## Zoning & Planning Committee Agenda

Tuesday, August 15, 2023

**#38-22 Request for discussion and amendments to the Zoning Ordinance and Zoning Map regarding village center districts**

Comments and possible amendments for VCOD  
Susan. Albright

## Detail of above image:

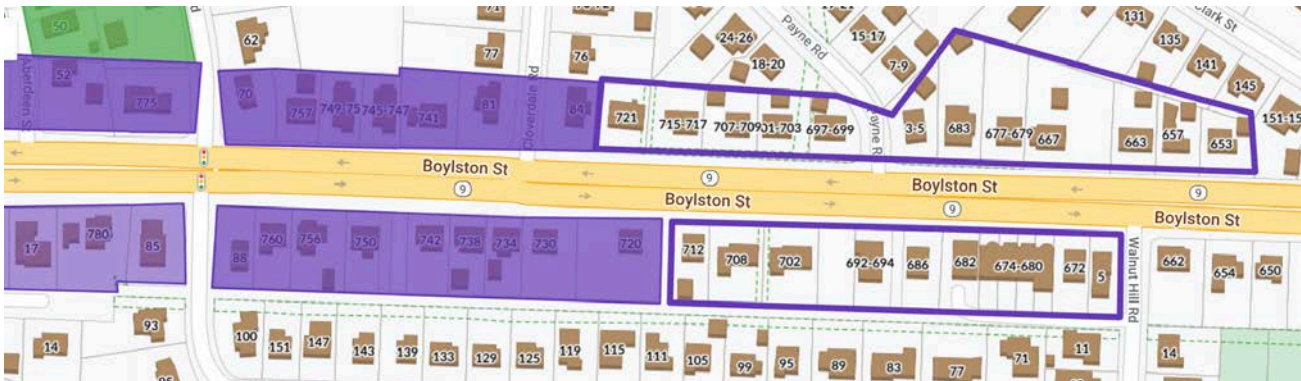
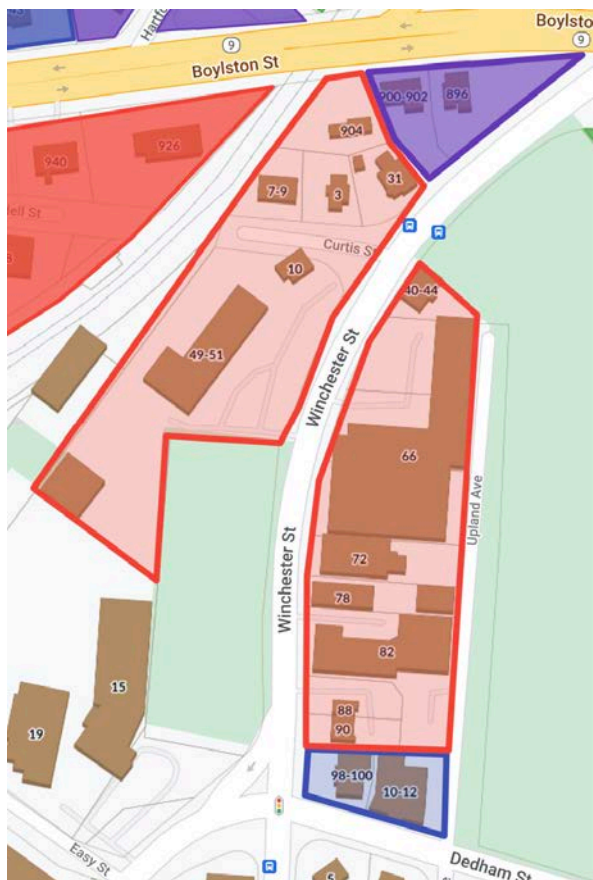
- Additional MRT to connect Newton Highlands to Eliot.
- There are many large Victorians on both Lincoln and Erie.
- Right next to Eliot are three lots owned by the same person. That's why the MRT goes up Harrison.

- Additional MRT down Walnut and Lake Ave. as they are so close to the T. There is an entrance to the T on Hyde St. so these lots are very close to transit.

- The section of VC1 that is not filled in with purple is hardly a walkable area.

### Auburndale

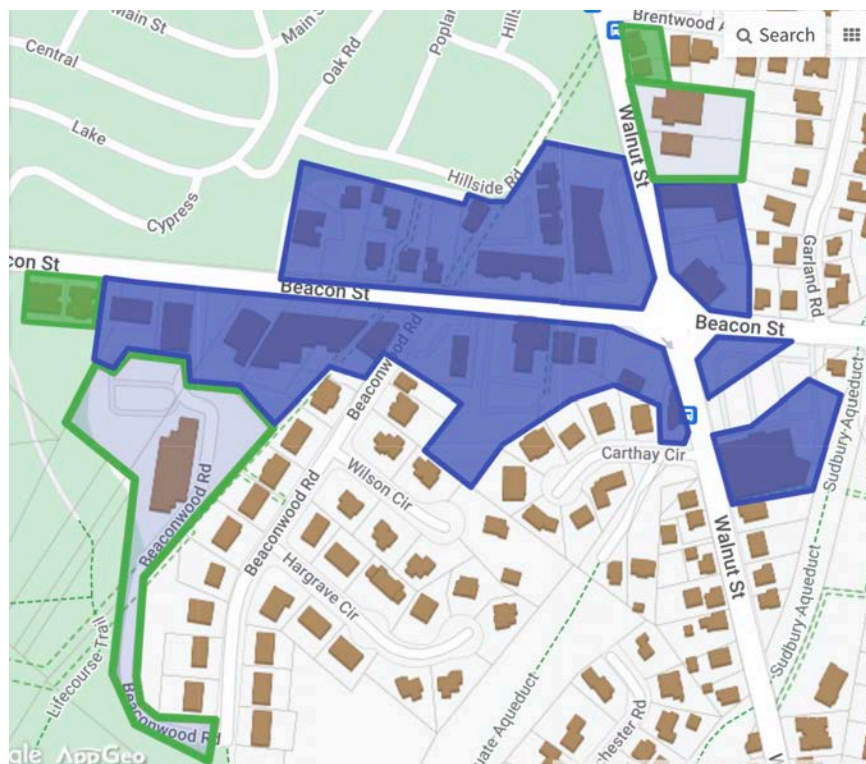
- The area for more VC2 on the left side of this map currently has Newton Housing Authority buildings. In future may want to do more.
- Star market and parking area could have more height, especially near the Pike

### Nonantum

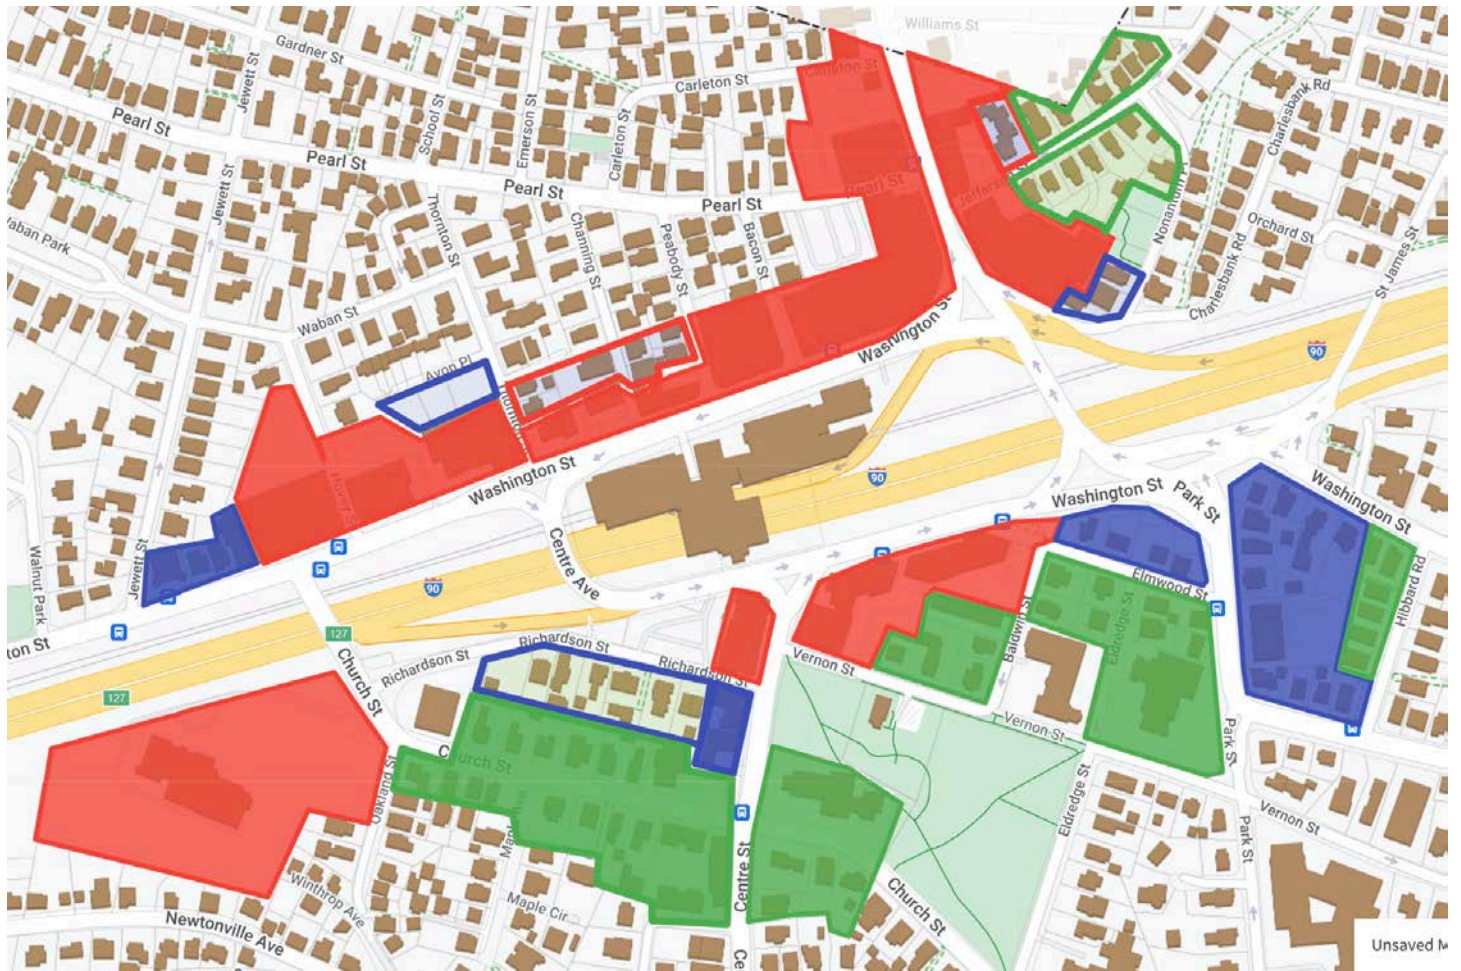
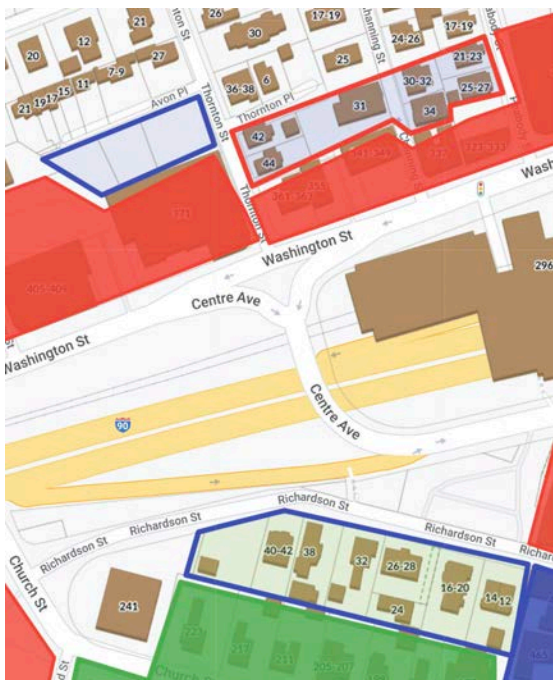
- Some of Nonantum could have VC3

- Detail from above map

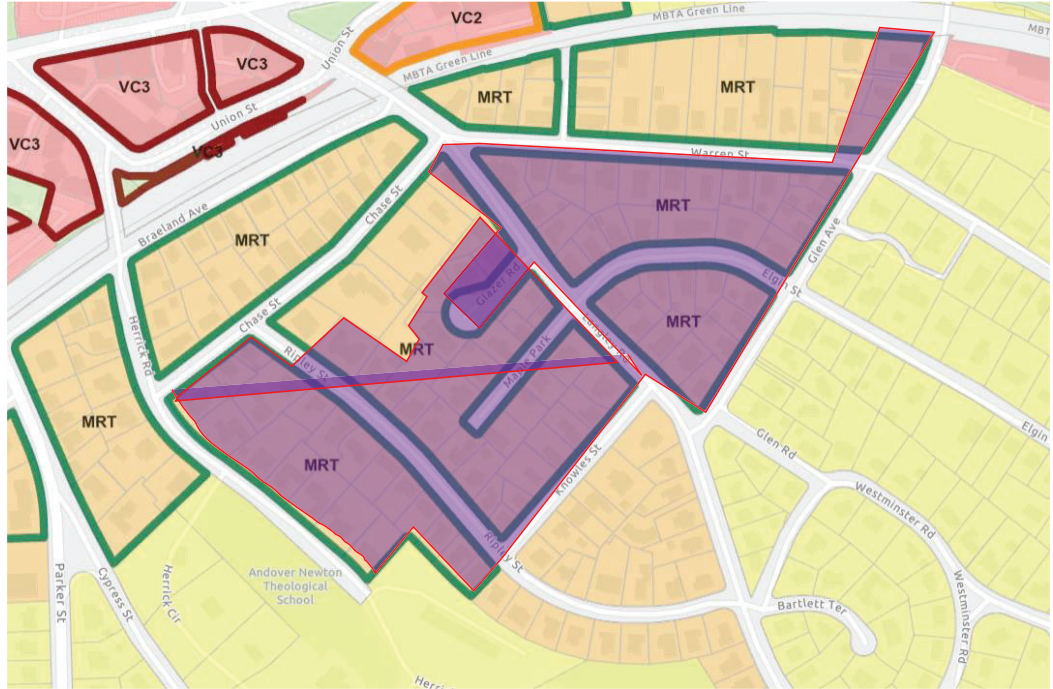
1. Change all parcels in the village of Newtonville on Walnut Street south of the Massachusetts Turnpike that are proposed in the overlay district as VC3 to VC2.

The reason for this change is simple. The densest and tallest buildings in Newtonville should be reserved for certain parcels along Washington Street. Allowing 5-story building along a narrow and small street will create a “canyon-like effect”. If a developer wishes to build 5-stories or taller, that should require a special permit. Also, the Washington Street Vision Plan, which was adopted in December 2019 and is part of Newton’s Comprehensive Plan, calls for a 4-story maximum building height on this section of Walnut Street. I have provided a link to the Washington Street Vision Plan, and a map from the vision plan which states a 4-story maximum building height on Walnut Street.

### Proposed Changes in Newton Center north of T

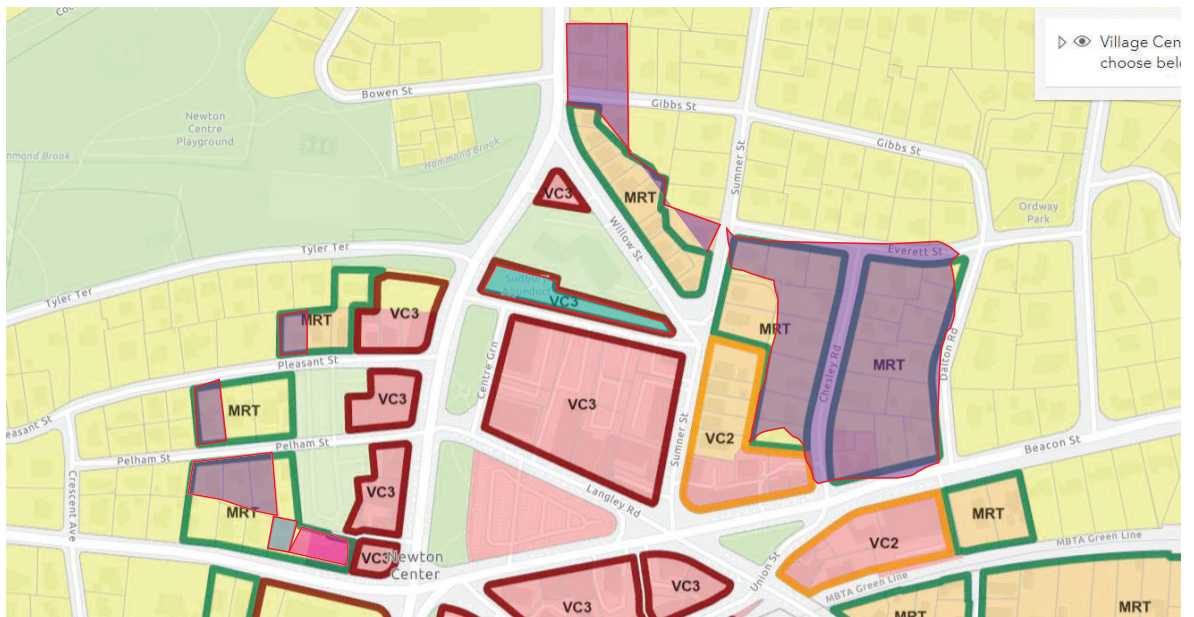
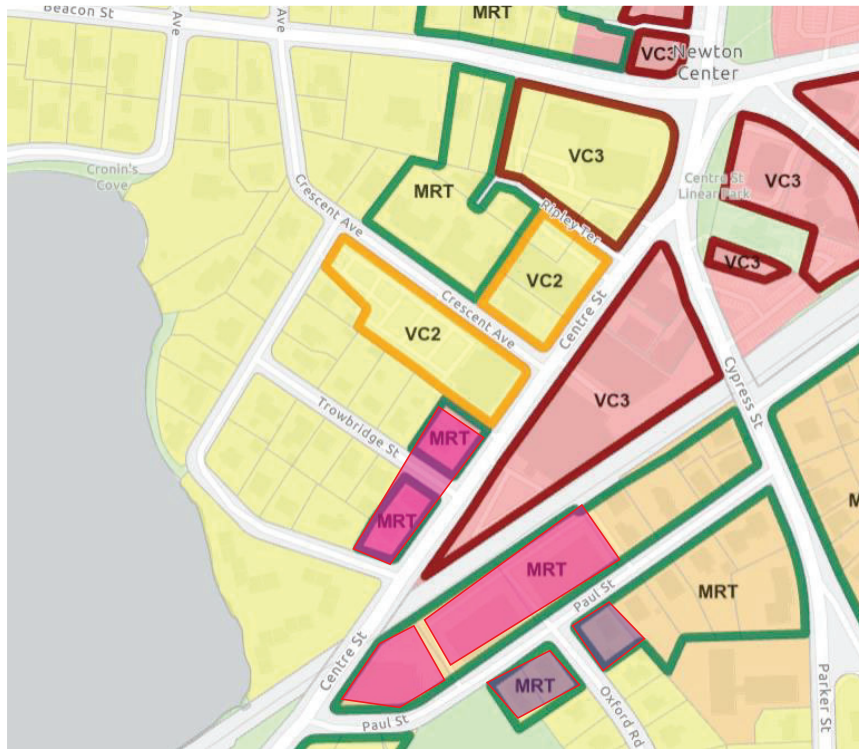
Remove these properties from MRT

Remove these properties from MRT

Add these properties to MRT

Change these properties from MRT to VC2 or VC3

### Proposed Changes in Newton Center west of T

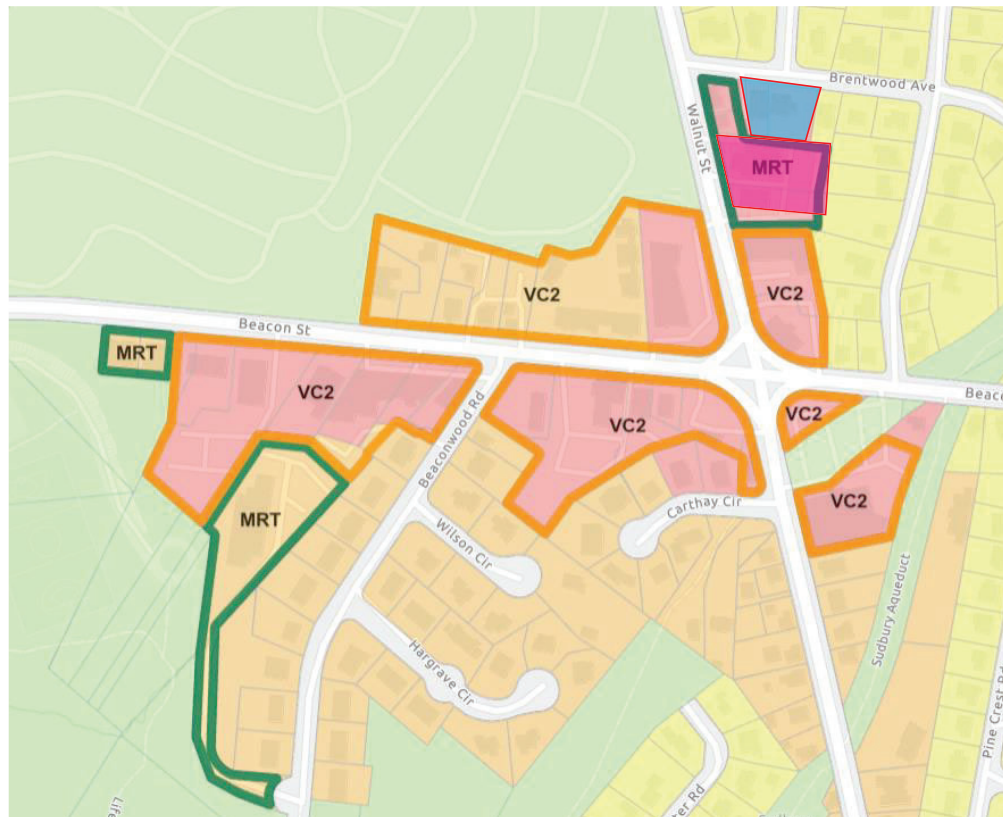
Change these properties from MRT to VC1

Remove this property from VC3

-  Remove these properties from MRT
-  Add these properties to MRT
-  Change these properties from MRT to VC2

### Proposed Changes in Four Corners

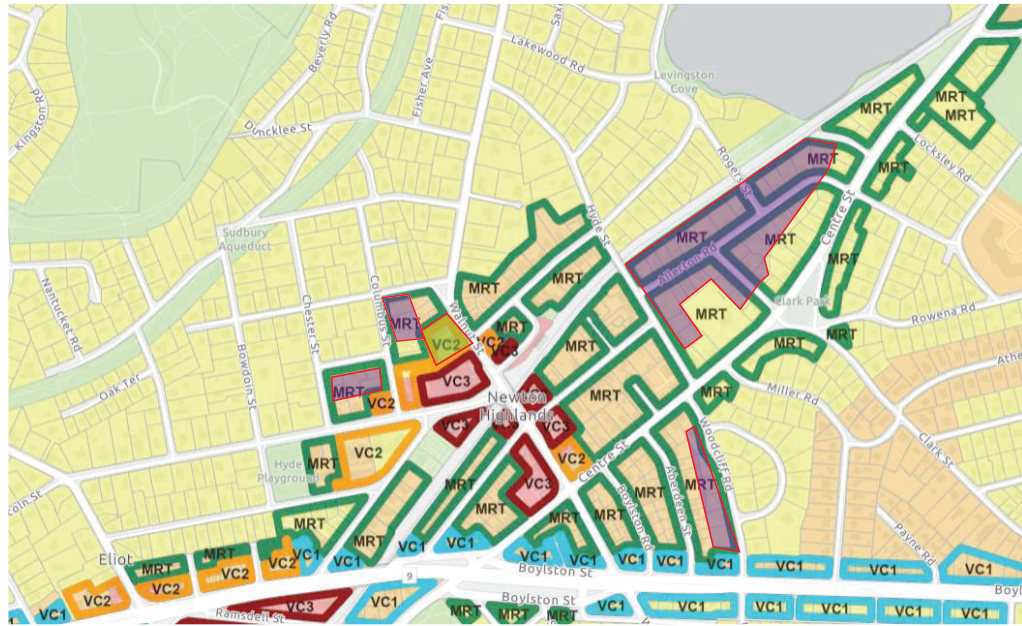
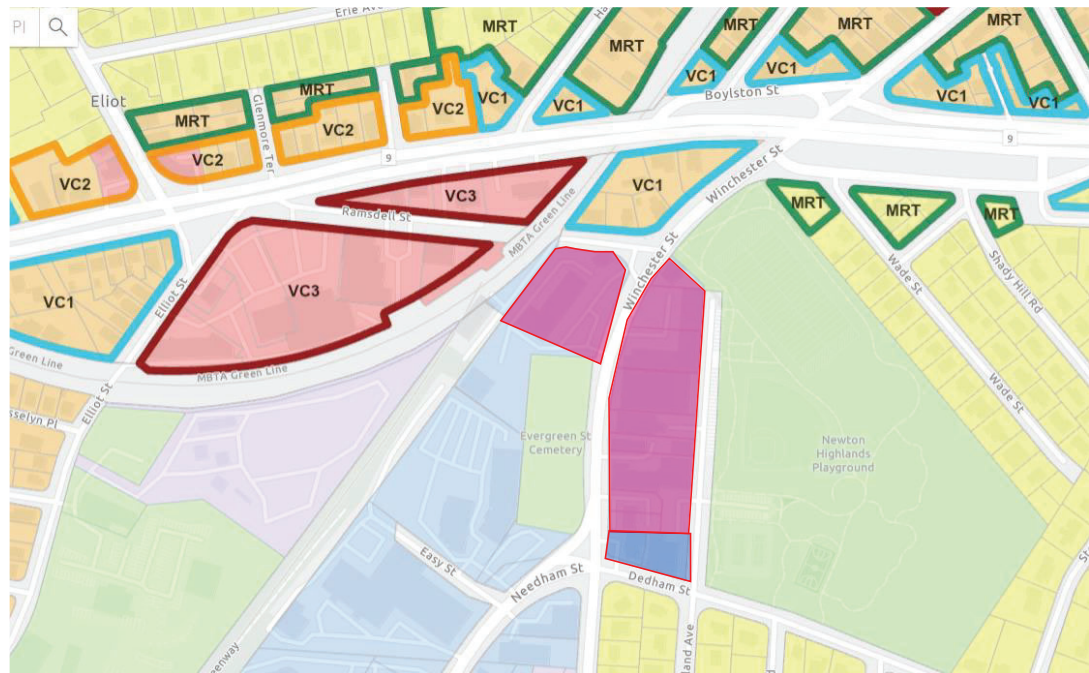
-  Add these properties to MRT
-  Add these properties to VC2
